Dear Mayor and Council of North Cowichan,

According to the 2022 June 29 Henry Road Safety Assessment, two 2.6m vehicles can safely pass on Henry Road.

This is a photo of a collection vehicle on Henry Road.

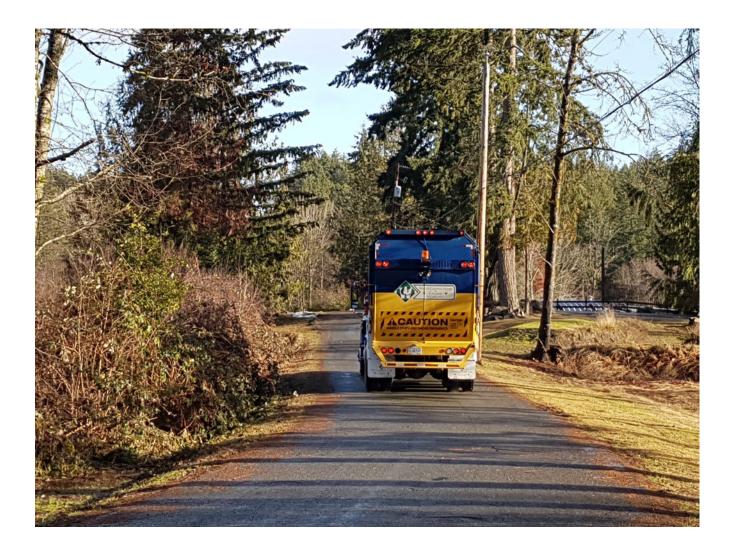
This contradicts 3.1 which accurately notes that there are no shoulders. How can a vehicle yield on the shoulder when there is no shoulder? They offered no further explanation about how two vehicles that are wider than the road can pass each other safely.

When I measure 5.2m out from the utility pole located to the right of this vehicle, it extends past the road and into the steep drainage ditch on the other side. This indicates to me that even though the Safety Assessment says it is possible for two vehicles that measure 2.6m each to pass on this section of Henry Road it is in fact impossible.

Looking at the above photo, do you think that the Safety Assessment is correct that two vehicles of this size could safely pass on this part of Henry Road? Could an SUV or truck safely pass this collection vehicle on this stretch of road? A car? What about cyclists or pedestrians?
